ADDENDUM NO. 2

Whiteland Community High School Phase 2A
300 E. Main Street
Whiteland, IN 46184

PROJECT: Whiteland Community High School Phase 2a

DATE OF ADDENDUM: May 2, 2024

SHEET 903

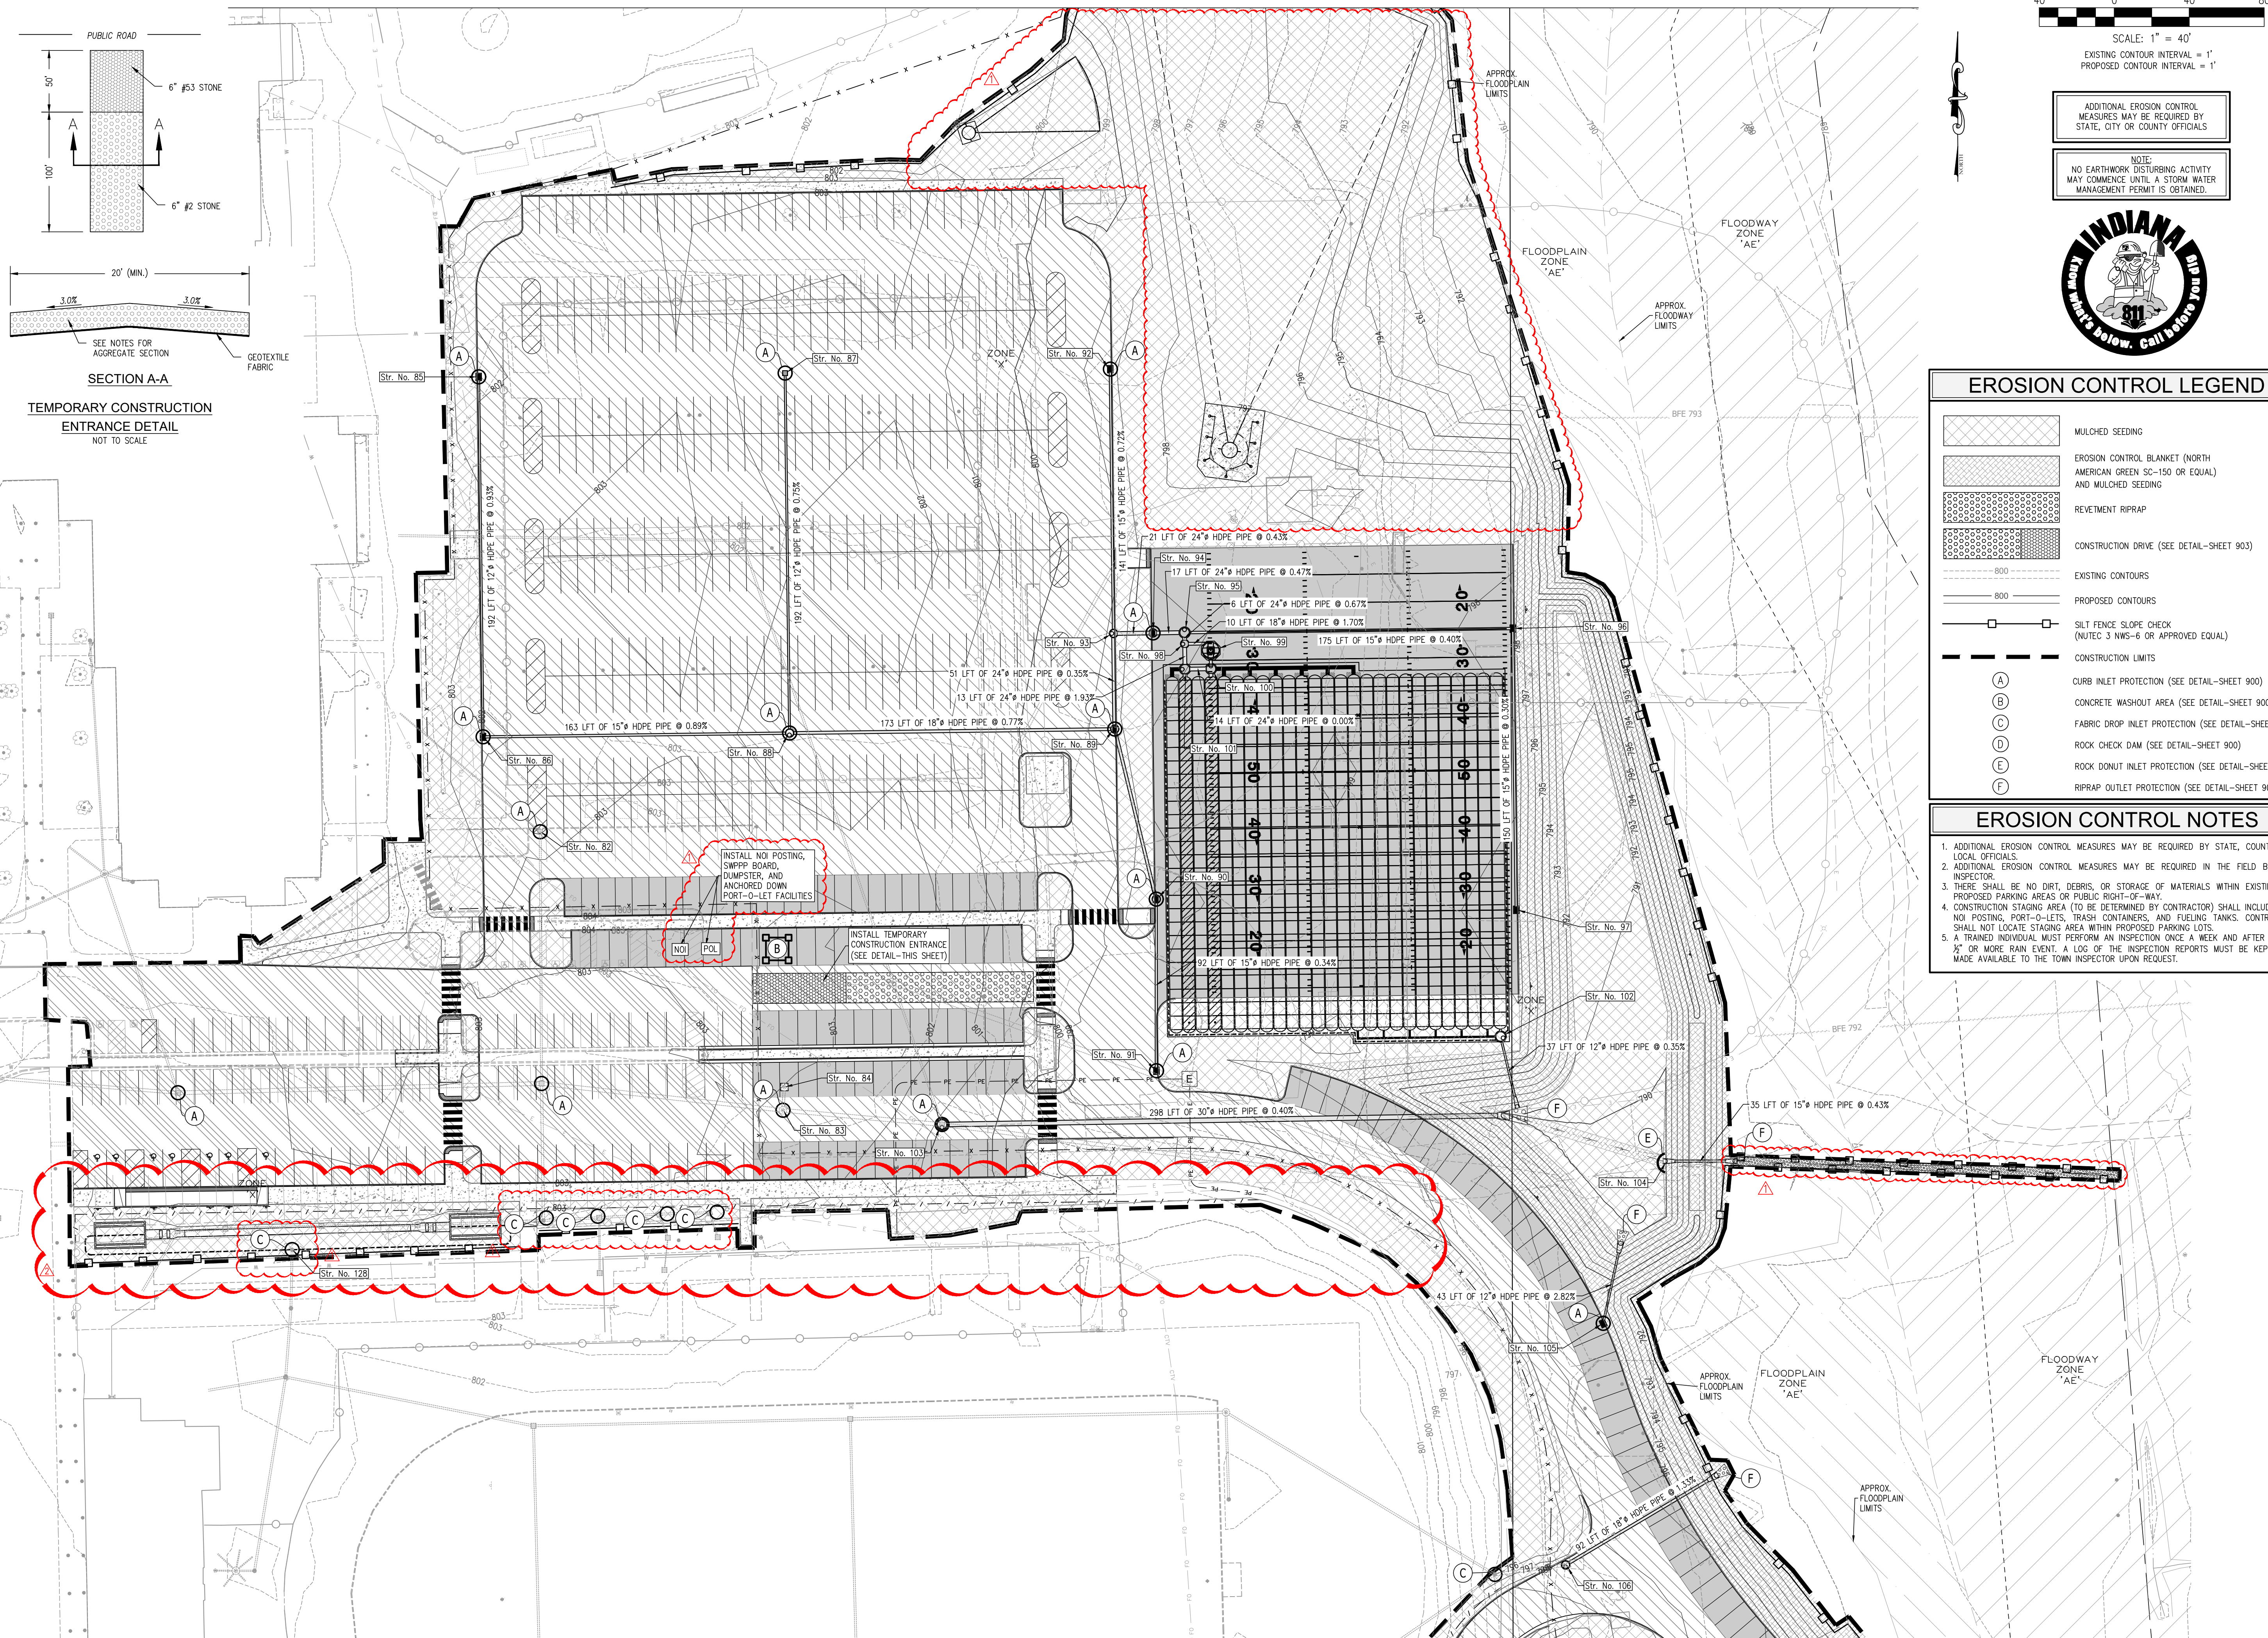
- o Str. No. 123 – revised invert elevations and slope of 24” HDPE pipe connecting Str. No. 121 and 123 as shown.
- 18 Erosion Control Plan (sheet 903):**

- o Revised mulched seeding hatch, silt fence, and construction limits based on revised long jump pit location.
 - o Revised to include fabric drop inlet protection around Str. No. 128.

PARALLEL CURB RAMP (F)
NOT TO SCALE

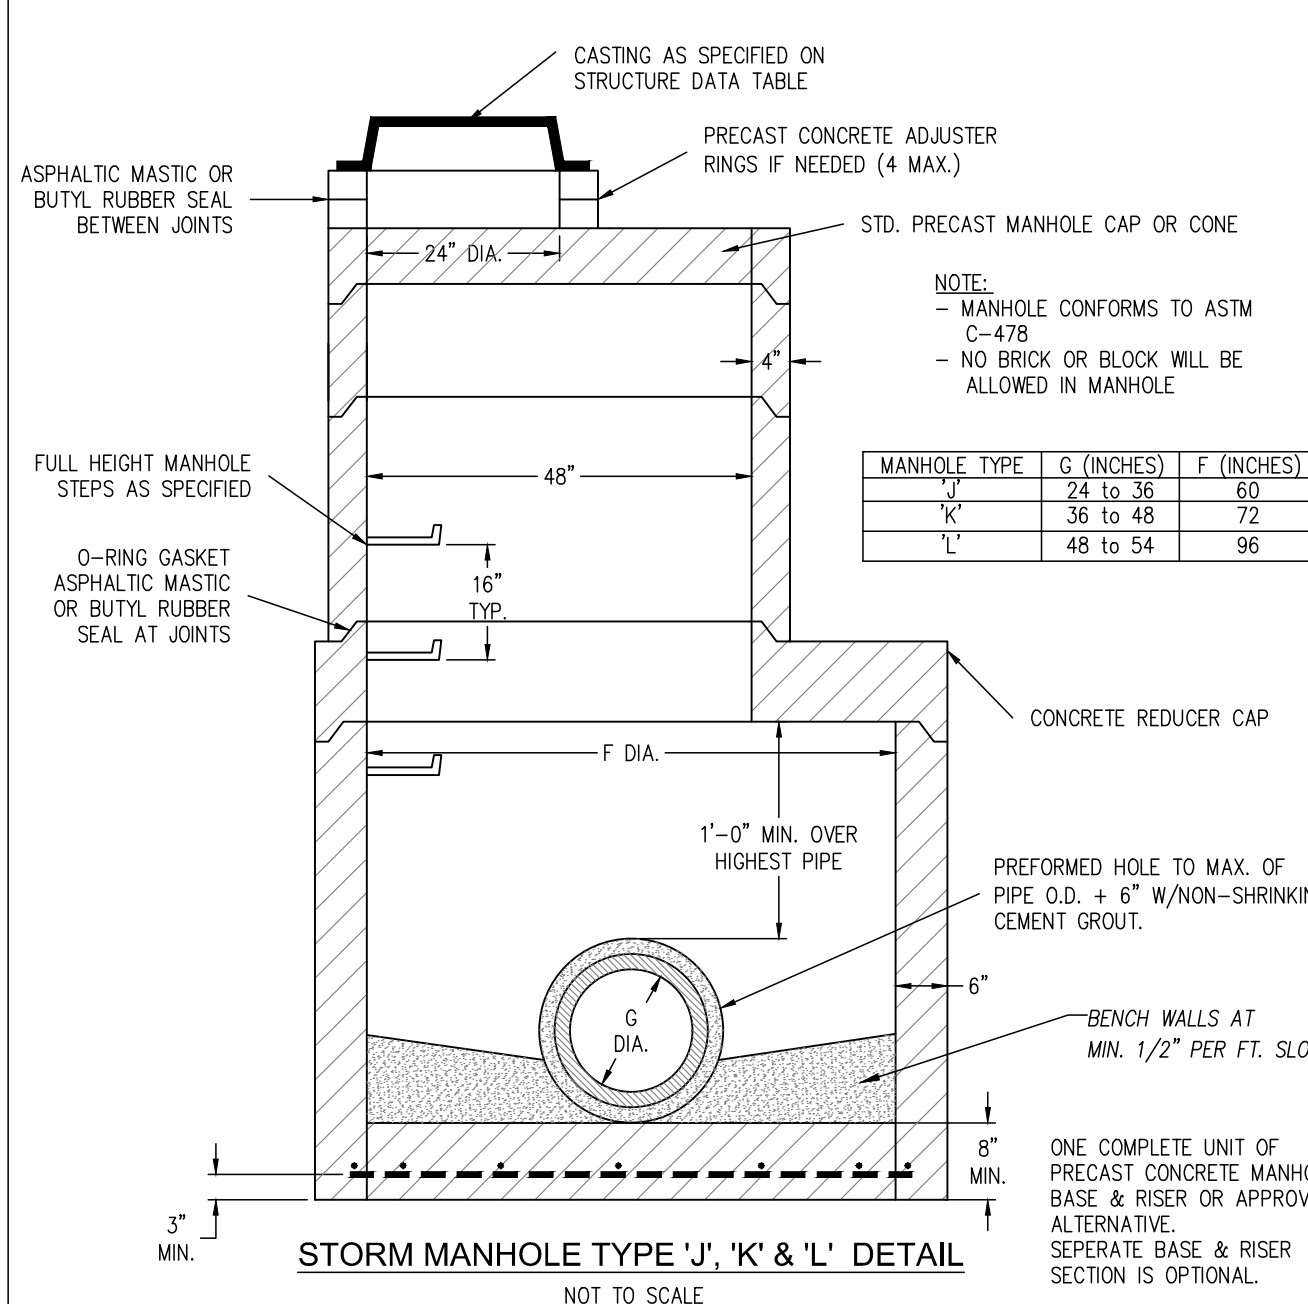
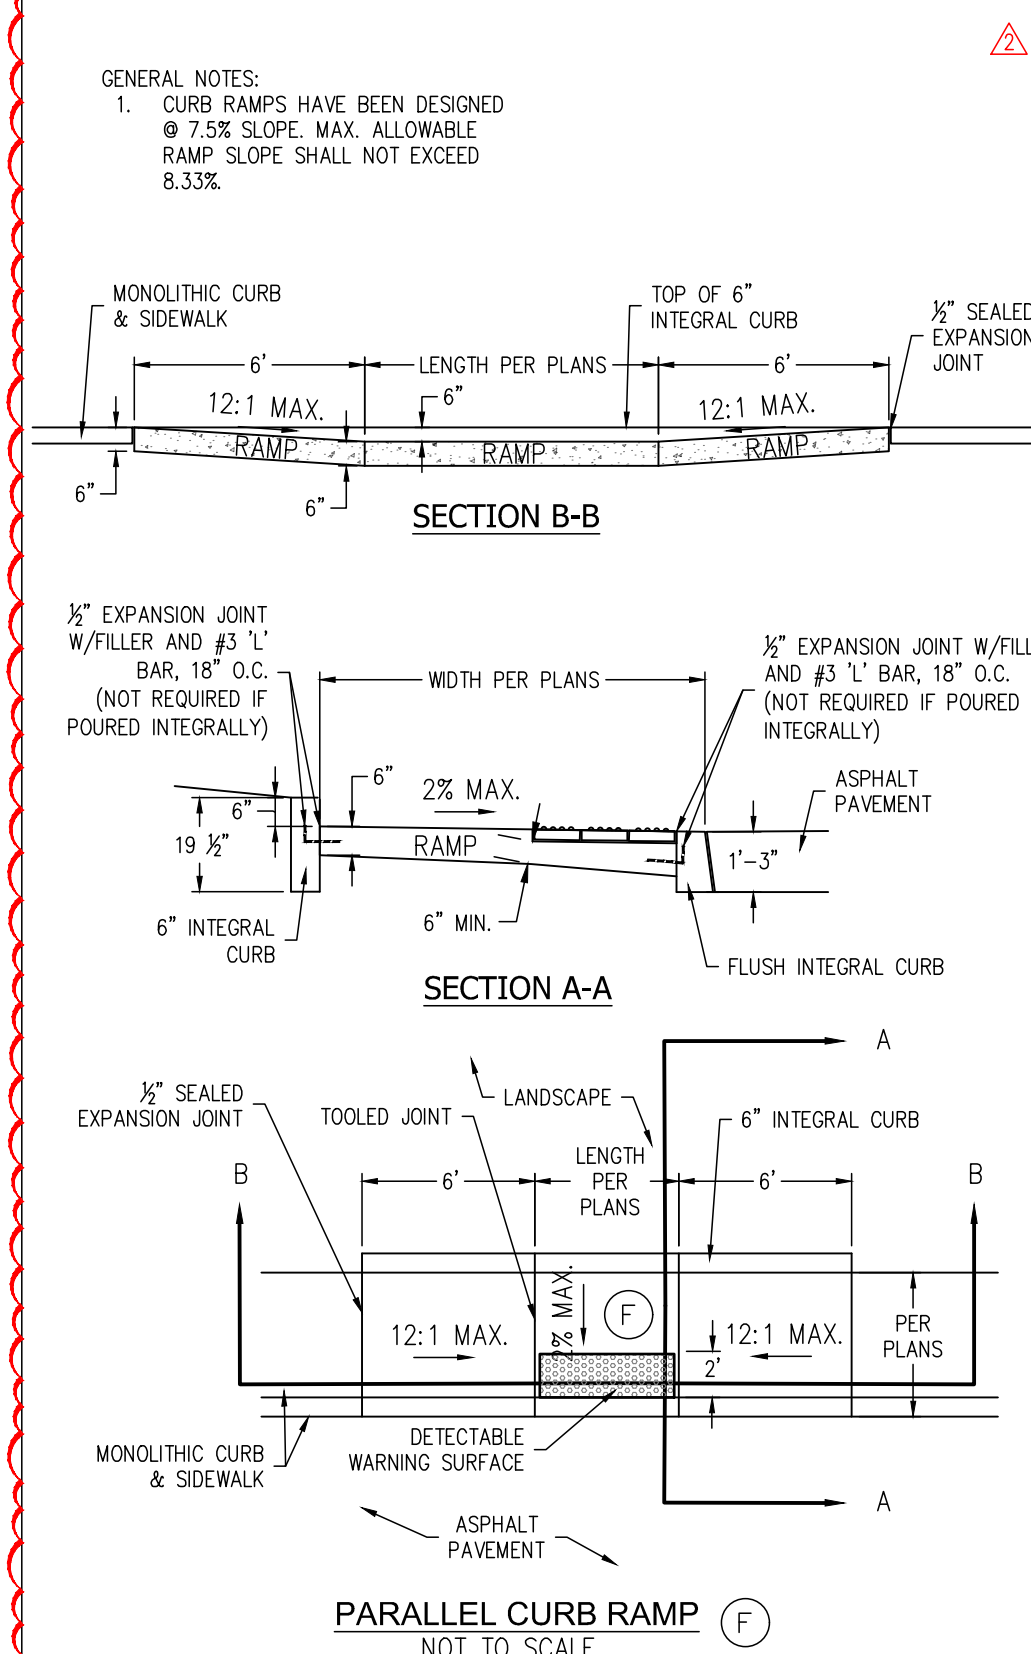
- 19 Miscellaneous Details (sheet 1000):**
 - o Revised A.D.A. parallel curb ramp detail (“F”) to include 6” tall integral curb on the backside of the curb ramp.

SITE MATERIALS PLAN -
PHASE 2A

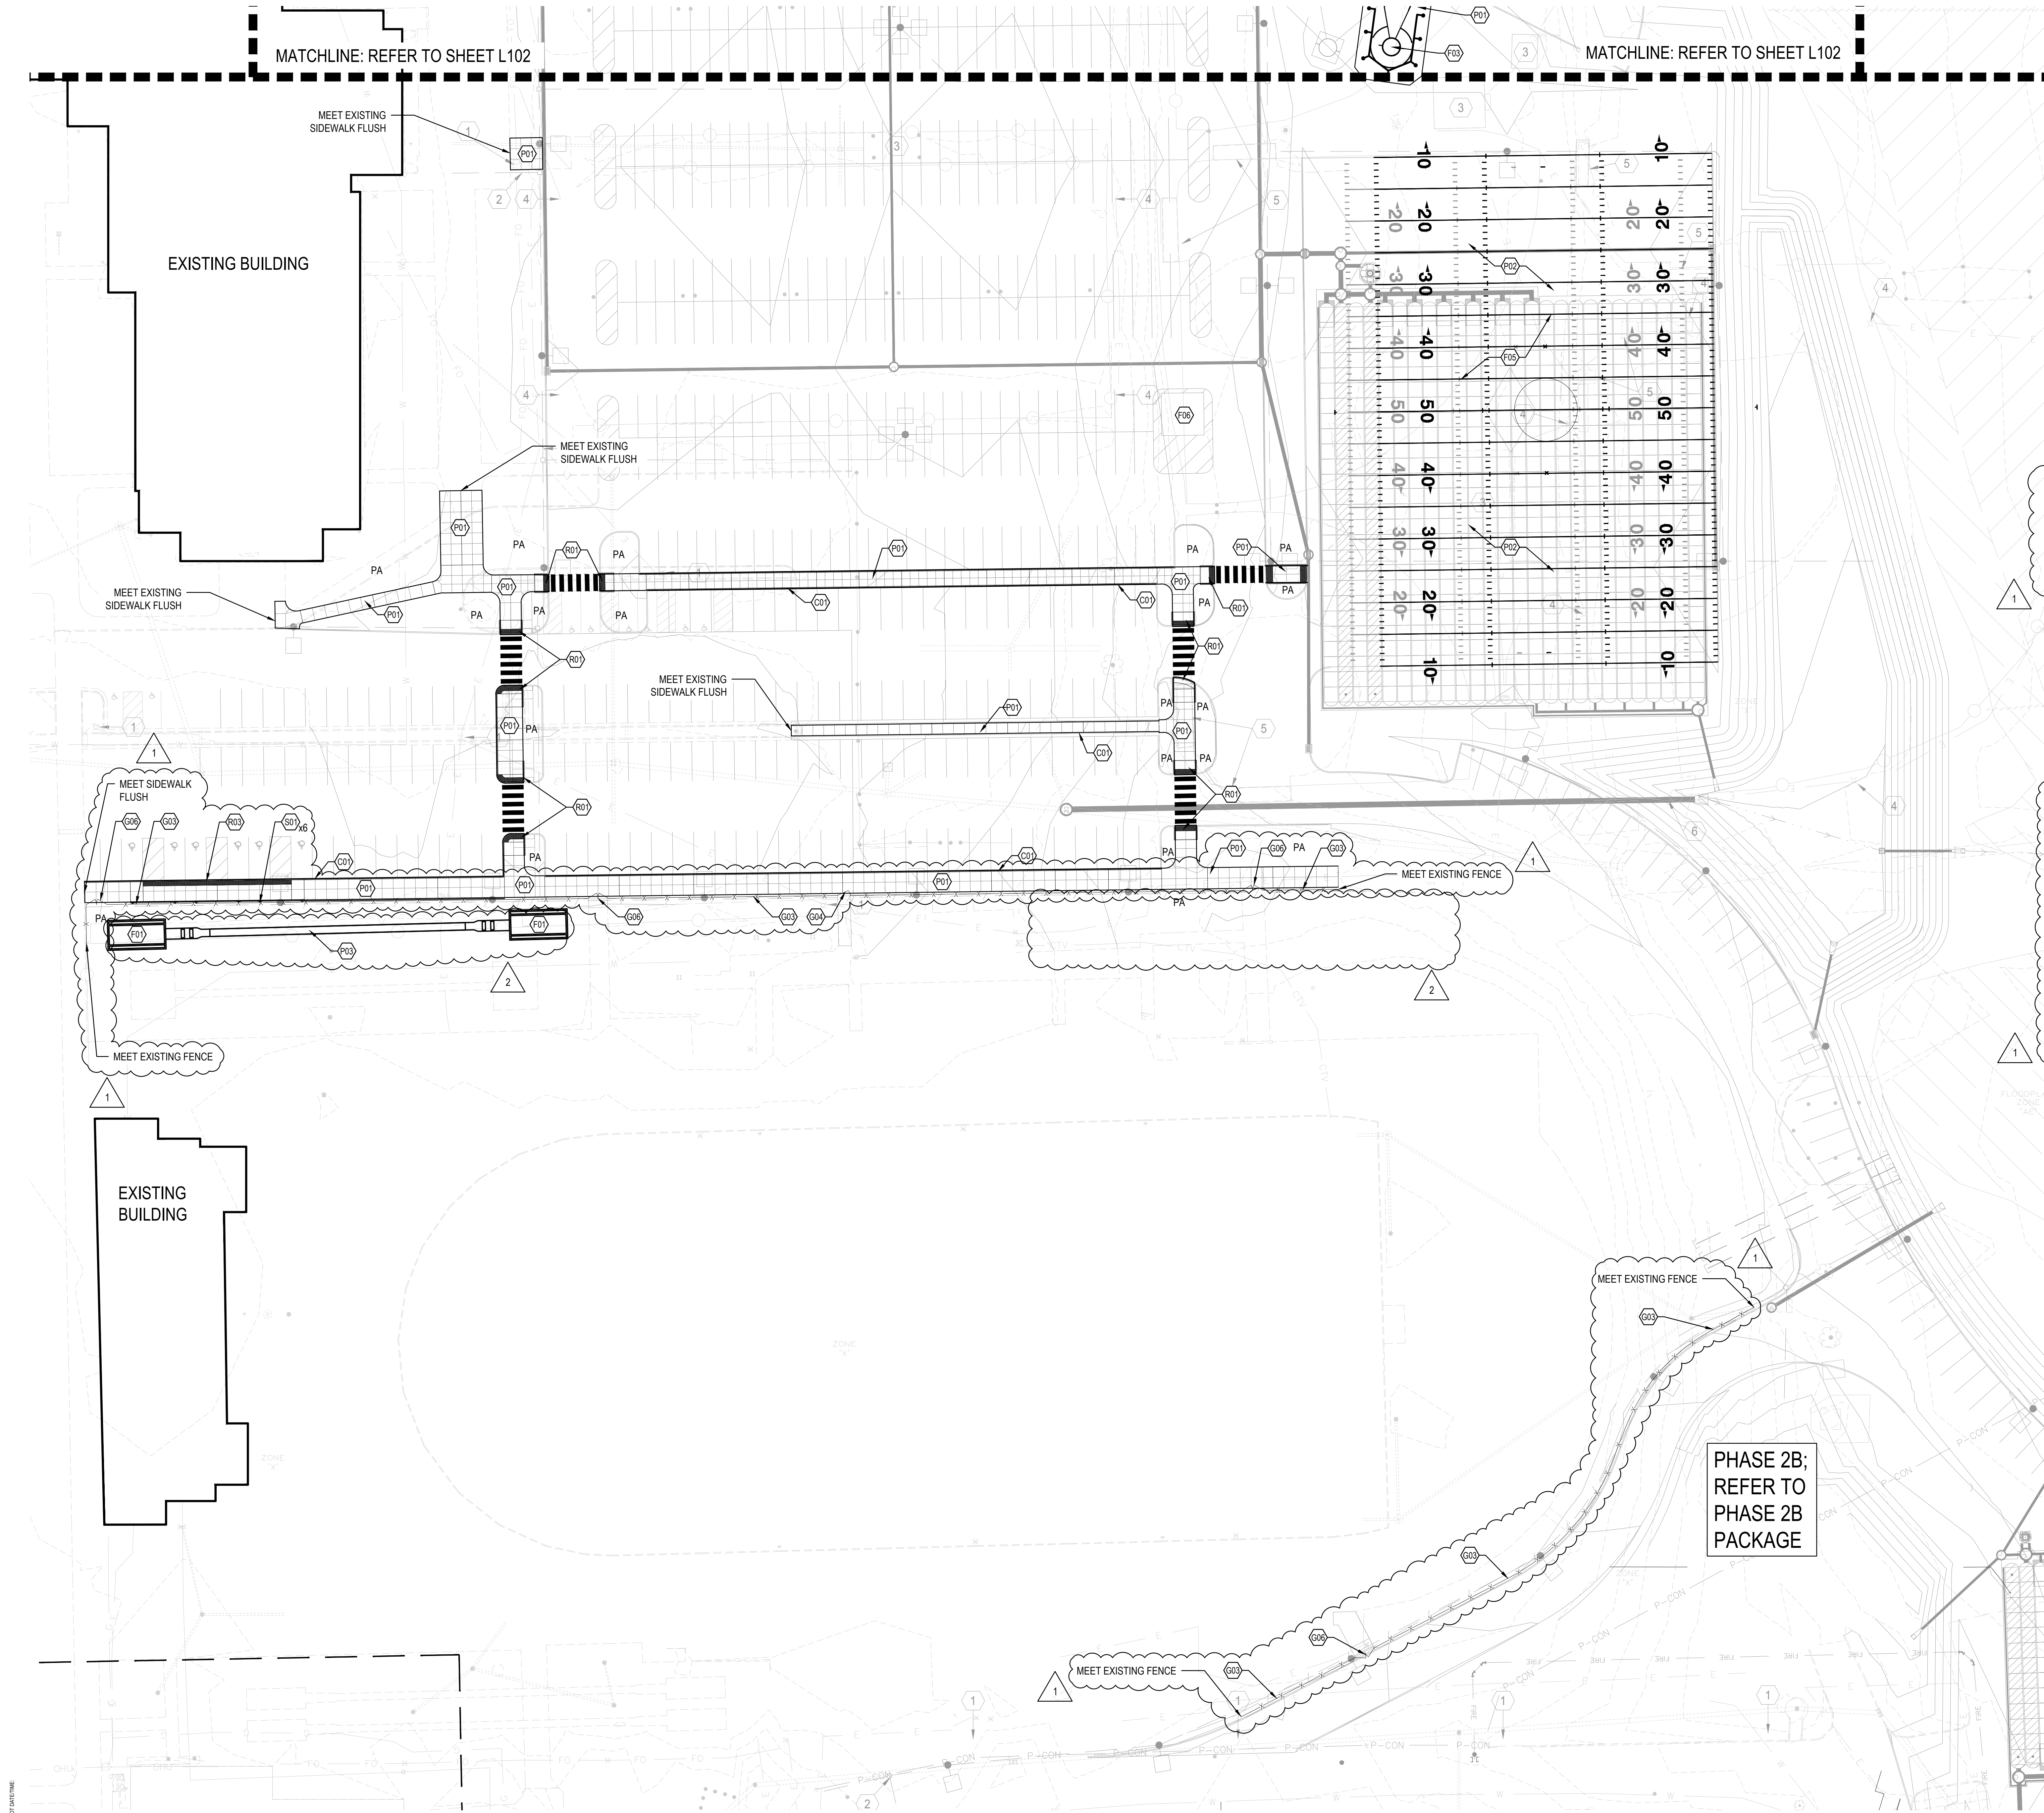
- 21. Drawing Sheet: L101 SITE MATERIALS PLAN – PHASE 2A**

Location of Long Jump revised.
- 22. Drawing Sheet: L201 SITE LAYOUT PLAN – PHASE 2A**
